Notice of changes to instruction manual, caution labels, class 1 label, etc. for Laser Photoelectric Sensor of E3Z-LL/LR/LT series due to FDA Standard upgrade

Photoelectric Sensors E3Z-LL/LR/LT series

Effective as of our production in Dec,2024.

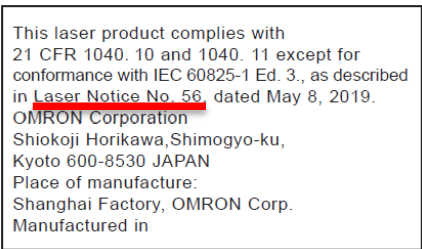
Before the change	After the change
<p>1) ① Caution label、②Aperture label is placed in packaging bag.</p> <p>2) "Laser Notice No. 50" record in the ③FDA certification label.</p> 	<p>1) Delete ①Caution label、②Aperture label</p> <p>2) "Laser Notice No. 56" record in the ③ FDA certification label.</p>

Before the change	After the change
<p>① One type of appearance One CLASS 1 laser product label is posted on the product and the other is placed in the packaging bag.</p>  <p>② Another type of appearance Class 1 laser product label is posted on the product two side</p> 	<p>① One type of appearance Delete two CLASS 1 laser product label</p>  <p>② Another type of appearance Delete two side Class 1 laser product label.</p> 
<p>Record the customer that the location of Caution label, CLASS 1 label, Aperture label is on the instruction manual.</p> <p>(1) Application in Japan According to JIS C6802:2014, the safety measures required of the user are stipulated according to the class of the laser device. The E3Z-L□□□ is classified as a class-1 laser according to JIS C6802:2014. Laser stickers The following stickers are attached to the side of the sensor.</p>  <p>(2) USA When a laser device is exported to the USA, it falls the laser regulations of the FDA (Food and Drug Administration). The E3Z-L□□□ is classified as a class-1 laser by the FDA, and it has already been registered with the CDRH (Center for Devices and Radiological Health). Ask your OMRON representative for details. Laser Labels Technical standards have been provided with the product. When exporting to the USA, refer to the following illustration and replace the label with the caution label. It is assumed that the E3Z-L□□□ will be incorporated into a final system device. When incorporating the E3Z-L□□□, comply with the following technical standard: US Federal Low 21 CFR 1040.10 and 1040.11 except for deviations pursuant to Laser Notice No.50, dated June 24, 2007</p> <p>Caution / Certification and Identification labels</p>  <p>Aperture labels</p>  <p>Aperture labels</p>  <p>(3) Regions except the USA When using in China, GB7247.1: 2012 (IEC60825-1:2007) applies to this product, it is classified as a Class 1 laser product. When using in other countries, IEC60825-1:2014/ EN60825-1:2014+A11:2021 applies to this product, it is classified as a Class 1 laser product.</p>	<p>Due to the deletion of Caution label, CLASS 1 label, Aperture label, the content recorded in instruction manual will be changed accordingly.</p> <p>(1) Application in Japan According to JIS C6802:2014, the safety measures required of the user are stipulated according to the class of the laser device. The E3Z-L□□□ is classified as a class-1 laser according to JIS C6802:2014.</p> <p>(2) USA When a laser device is exported to the USA, it falls the laser regulations of the FDA (Food and Drug Administration). The E3Z-L□□□ is classified as a class-1 laser by the FDA, and it has already been registered with the CDRH (Center for Devices and Radiological Health). Ask your OMRON representative for details. Laser Labels Technical standards have been provided with the product. When using a device equipped with the product in the U.S., attach an FDA certification label near the sensor mounted on customer equipment. It is assumed that the E3Z-L□□□ will be incorporated into a final system device. When incorporating the E3Z-L□□□, comply with the following technical standard: US Federal Low 21 CFR 1040.10 and 1040.11 except for deviations pursuant to Laser Notice No.56, dated May 8, 2019</p> <p>Certification and Identification labels</p>  <p>(3) Regions except the USA When using in China, GB7247.1: 2012 (IEC60825-1:2007) applies to this product, it is classified as a Class 1 laser product. When using in other countries, IEC60825-1:2014/ EN60825-1:2014+A11:2021 applies to this product, it is classified as a Class 1 laser product.</p>
